Re: *Item PG30.4, June 7, 2018*
Midtown in Focus: Final Report
Greenrock Properties

Re: Midtown in Focus: Proposed Yonge-Eglinton Secondary Plan Update

APPENDIX A: MASSING ANALYSIS

SITE 1

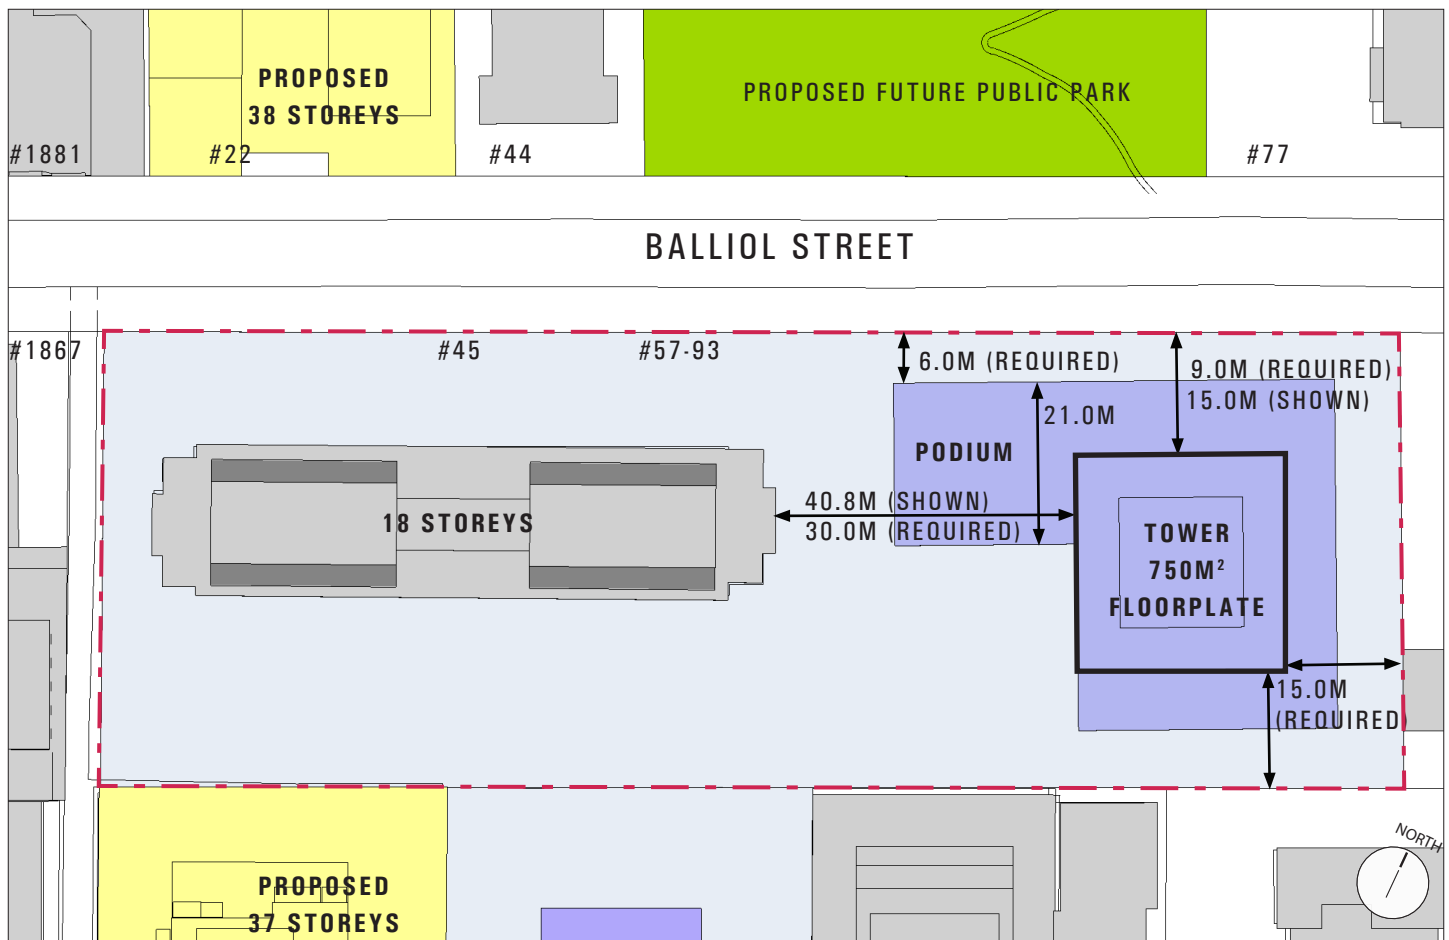
2. A portion of Site 1 (57-93 Balliol Street) is identified as having "Infill Development Potential", with a maximum height of 17-19 storeys on Maps 21-6 and 21-9, respectively. We are of the opinion that the height limit of 17-19 storeys is unnecessarily restrictive and does not consider a number of factors.

First, the height context includes existing buildings with heights significantly greater than 17-19, including the 28-storey MYC Condos (southeast corner

Second, it is our opinion that the 17-19 height limit is unnecessarily restrictive as it does not appear to fully consider the minimal resulting built form impacts. After applying all of the applicable proposed built form policies (see Appendix A), and evaluating the resultant shadow impact, it is our opinion that a tall building of at least 28 to 30 storeys would be appropriate given the current height context.

As such, it is our opinion that a height range in the order of at least 28 to 30 storeys is more appropriate on Site 1.

A height range in the order of at least 28 to 30 storeys should be applied to 45 Balliol Street and 57-93 Balliol Street.

SITE 2

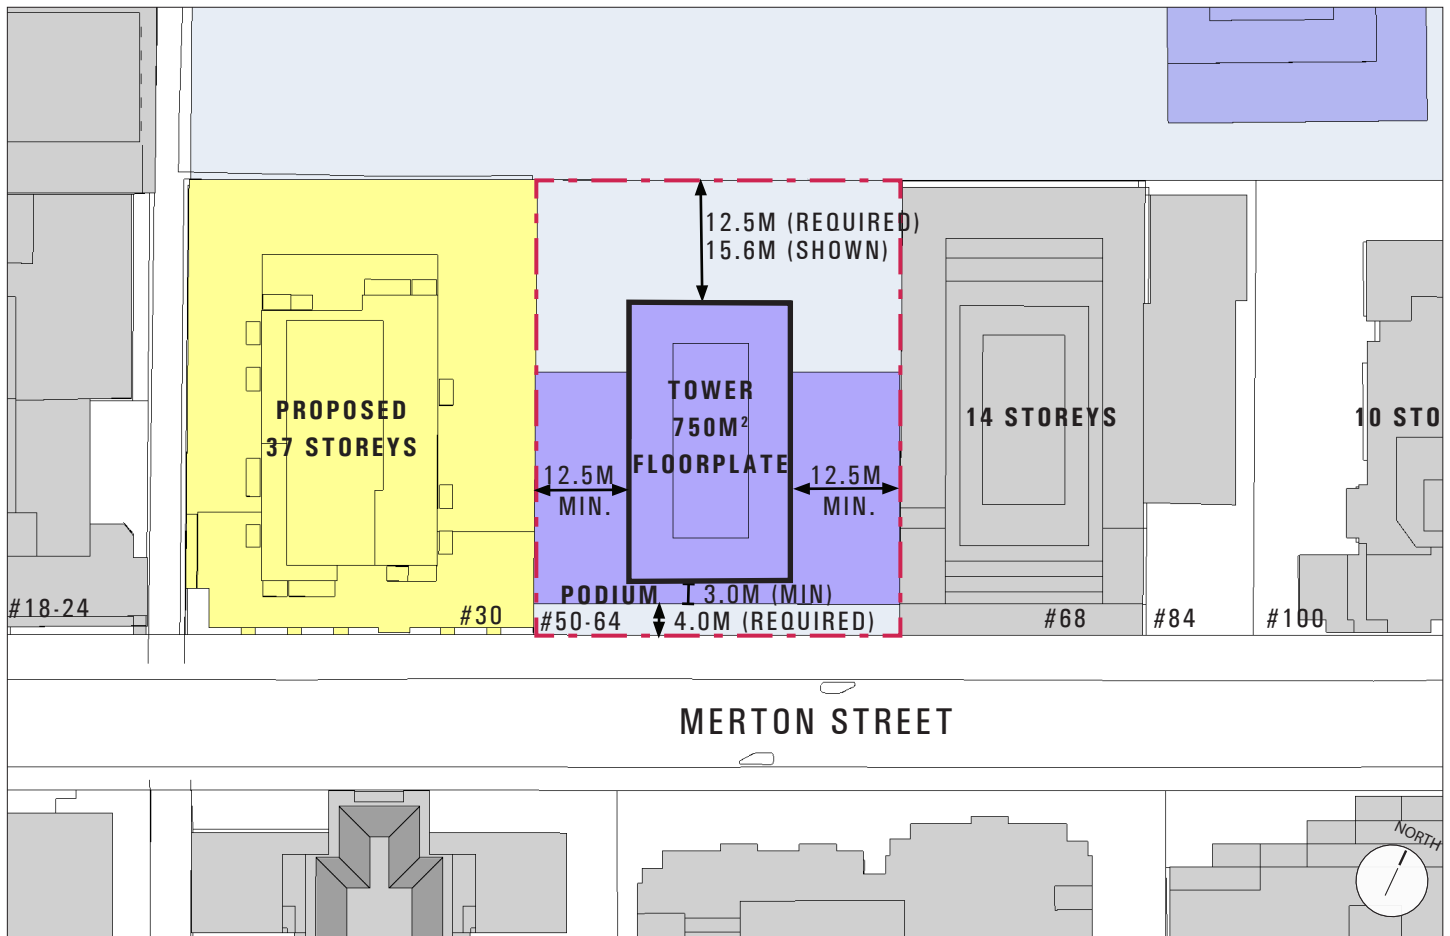
3. Site 2 (50-64 Merton Street) is a potential assembly of 64 Merton Street, currently owned by Greenrock, and 50 Merton Street, currently owned by the Girl Guides of Canada (“Guides”). Both properties are designated as being part of a “Midtown Special Place”, and specifically “Merton Street”, on Map 21-12. Both are also identified as having “No Tall Building Potential or Infill Potential” on Map 21-6.

While, individually, neither property is large enough to accommodate a tall building while meeting all of the proposed built form policies in the draft Secondary Plan, an assembled site can. Through a site-specific analysis of these two properties, we find that the assembled site can accommodate a tall building while meeting the relevant built form policies proposed for the “Merton Street” “Midtown Special Place” in Section 4.5.6 and for Tall Buildings in Section 3.3.4.

Specifically, given the assembled site’s width of approximately 47 metres, a tall building can be constructed with a maximum floor plate of 750 square metres (Policy 3.3.14), that is set back a minimum of 12.5 metres from the side and rear property lines (Policy 3.3.14) and 3.0 metres from the face of the base building along Merton Street (Policy 3.3.17), while setting the entire building back 3.0 metres from Merton Street (Policy 3.2.28). See Appendix A for an illustration.

With respect to an appropriate height limit, given the current height context and the proximity to Site 1 (57-93 Balliol Street), it is our opinion that a minimum height of approximately 32 to 34 storeys would be appropriate.

As such, we recommend that the 50-64 Merton Street properties be redesignated as lands with “Tall Building Potential” on Map 21-6. In our opinion, a height range of at least 32 to 34 storeys would be appropriate.

A height range in the order of at least 32 to 34 storeys should be applied to 50-64 Merton Street.

SITE 3

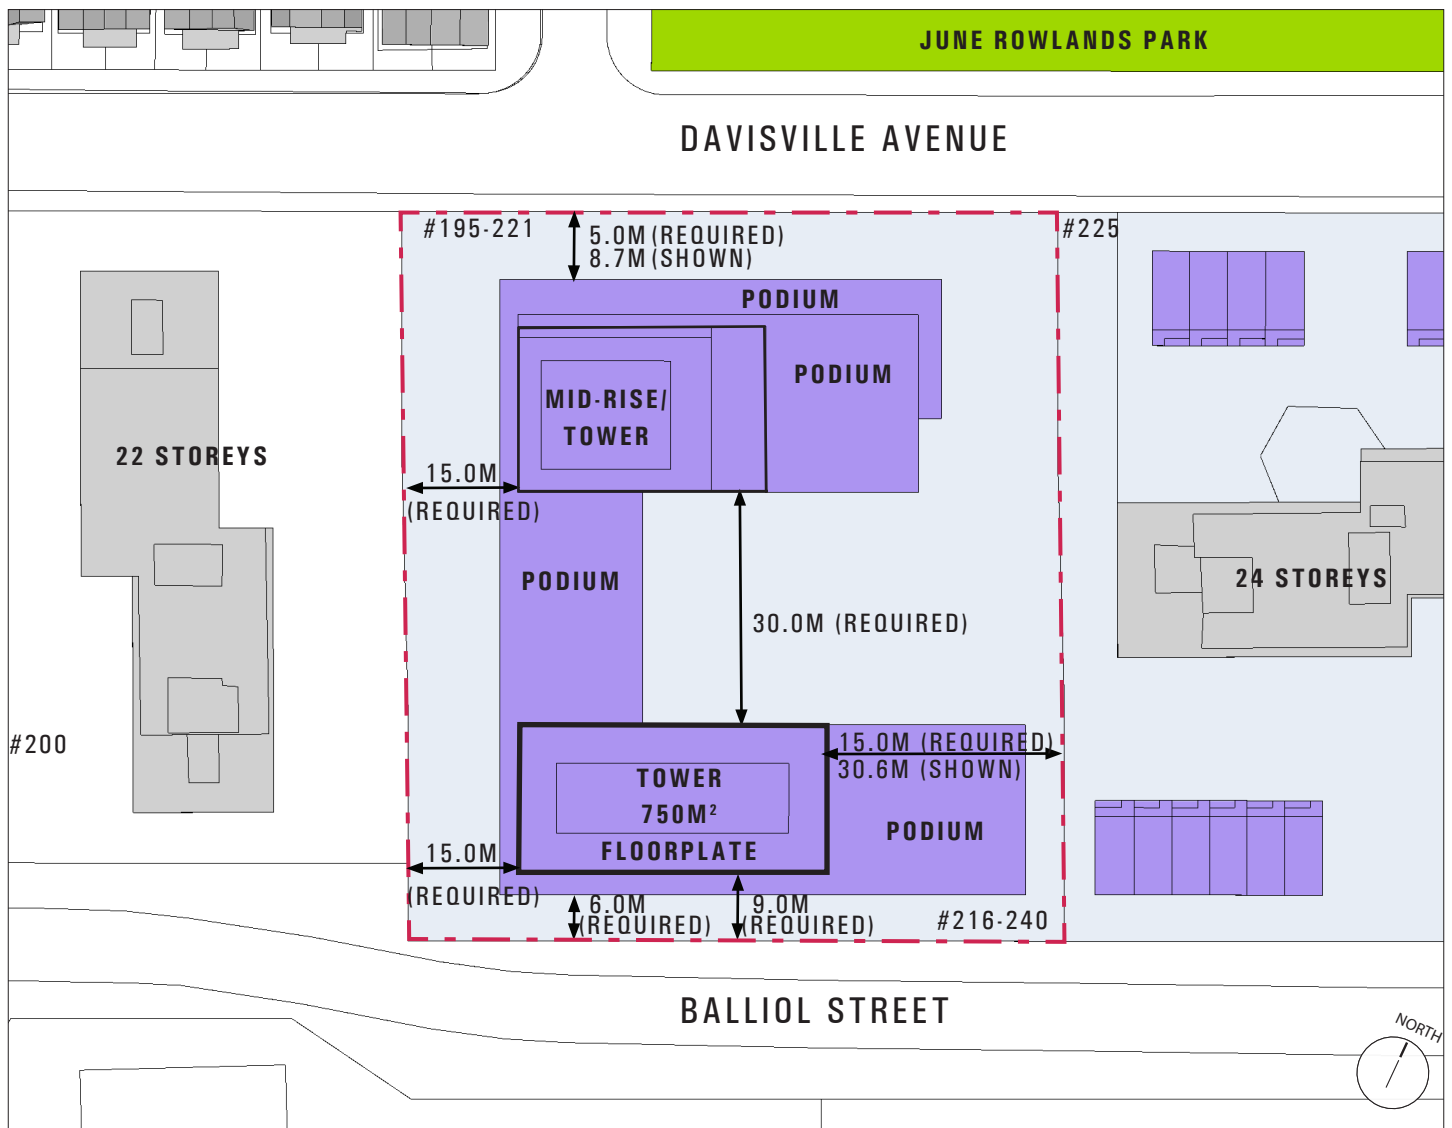
4. Generally speaking, Site 3 is designated as having “Tall Building Development Potential” on Map 21-6, taking into account the potential land assembly of the properties fronting Balliol Street (216-240 Balliol Street) and the rear of 200 Balliol Street. However, we are concerned that both the maximum height of 20-23 storeys proposed by Map 21-9 and the limited boundary of the potential assembly is unnecessarily restrictive.

Given the presence of *Neighbourhoods* immediately northwest of the site and the June Rowlands Park immediately northeast, we have analyzed the shadow impacts of a taller building on the site. Our shadow study showed that a tall building with a minimum height of 26-28 storeys could be accommodated on the site, depending on tower location and configuration, meeting all of the proposed relevant built form policies, with no new net shadowing on any portion of June Rowlands Park and limited shadowing on properties designated *Neighbourhoods* (see Appendix A).

In addition to a potential tall building framing the Balliol Street portion of the site, our analysis has demonstrated that a mid-rise building up to approximately 11 or 12 storeys could be accommodated along Davisville Avenue, generally on the lands at 195-221 Davisville Avenue. This could be achieved with no new net shadow impacts on June Rowlands Park and limited shadow impacts on lands designated *Neighbourhoods*.

In light of this, and given that we have demonstrated that an 11- or 12-storey height can be achieved without significant built form impacts, we recommend that either:

- (a) the “Tall Building Potential” designation applying to 216-240 Balliol Street and a portion of 200 Balliol Street on Map 21-6 be extended to include 195-221 Davisville Avenue; or**

(b) a maximum mid-rise height limit of at least 11 to 12 storeys be included in Section 4.3 of the Secondary Plan.

A height range in the order of at least 11 to 12 storeys should be applied to 195-221 Davisville Avenue, as opposed to 8 storeys.
